REVISED RESPONSE TO REQUEST FOR ADDITIONAL INFORMATION

APR1400 Design Certification

Docket No. 52-046

RAI No.: 175-8034
SRP Section: 05.04.12 – Reactor Coolant System High Point Vents
Application Section: 5.4.12
Date of RAI Issue: 08/20/2015

Table 5.4.12-1

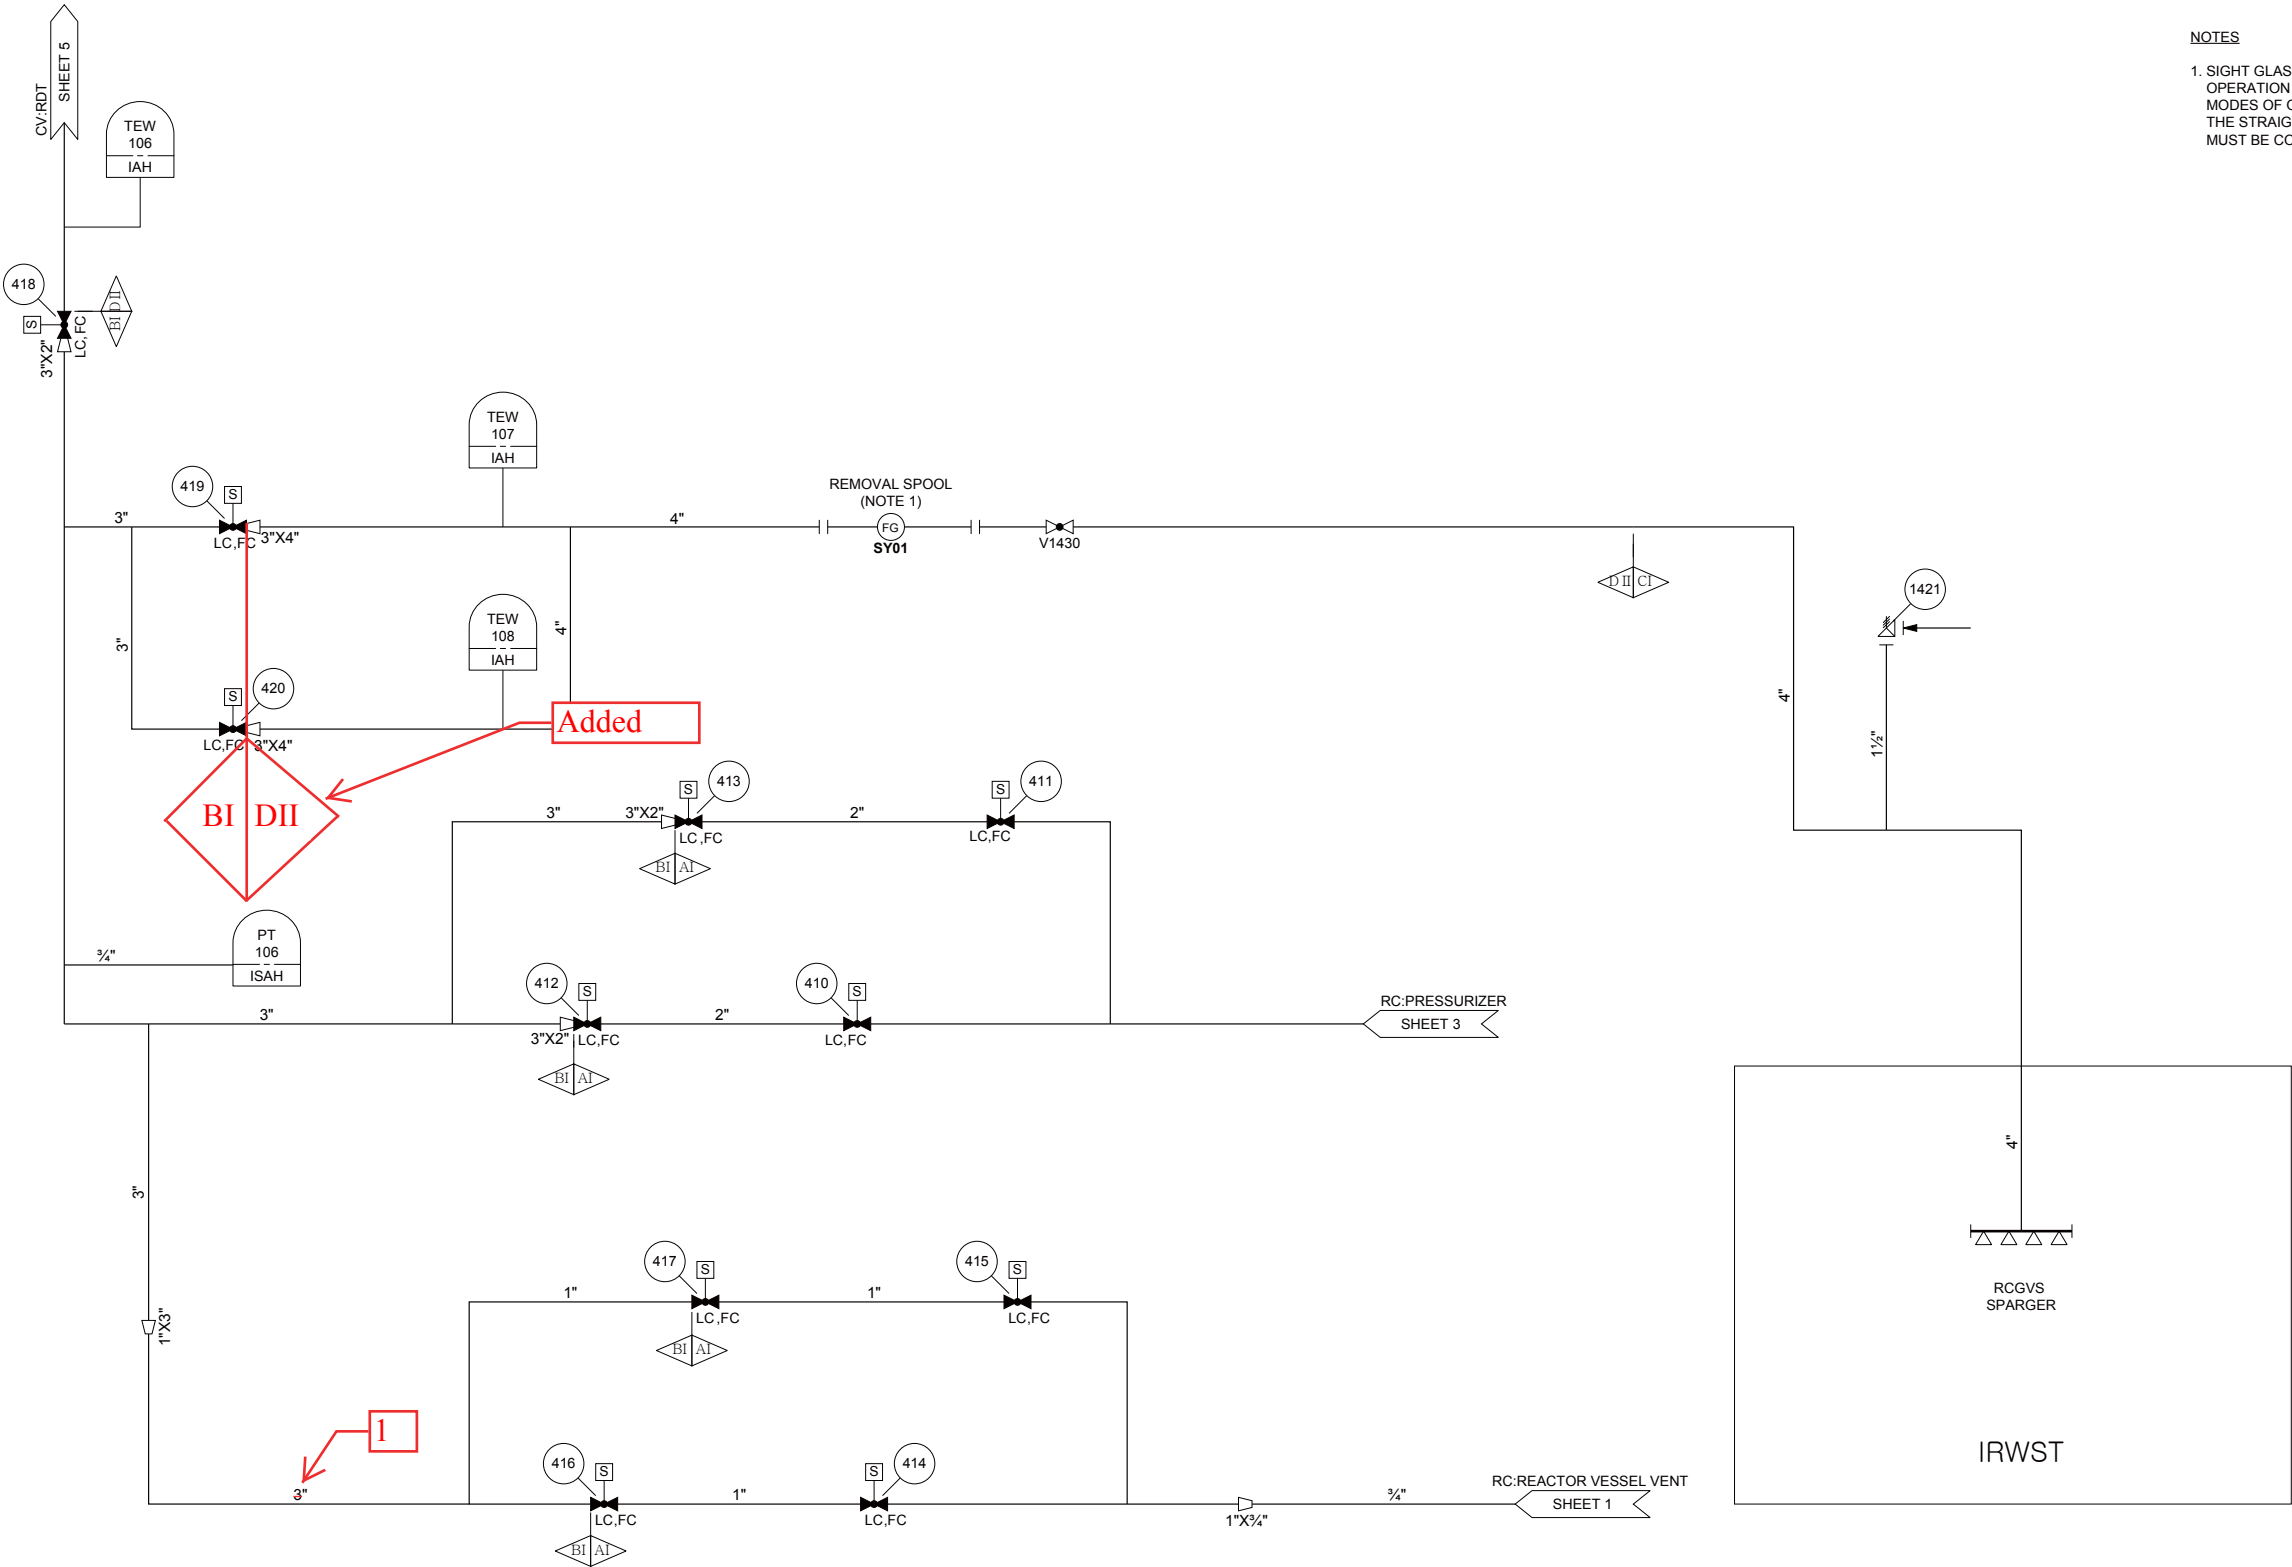
- a. In DCD Tier 2, Table 5.4.12-1, "Reactor Coolant Gas Vent System - Active Valve List," the Safety Class column appears to be inconsistent with the information in DCD Tier 2, Table 3.9-4, "Seismic Category I Active Valves," and DCD Tier 2, Table 3.9-13, "Inservice Testing of Safety-Related Pumps and Valves." In particular, the safety class for each valve in Table 5.4.12-1 is listed as the Roman numeral "I". Both Table 3.9-4 and Table 3.9-13 list RG-0410 through RG-0417 as Quality Group A and RG-0419 and RG-0420 as Quality Group B.

The safety class of valves RG-419 and RG-420, [and line size of RG-414](#) in DCD Tier 2, Table 5.4.12-1 will be corrected as shown in Attachment 1. Table 5.4.12-1 will also change safety class Roman numeral I to the number 1 for consistency.
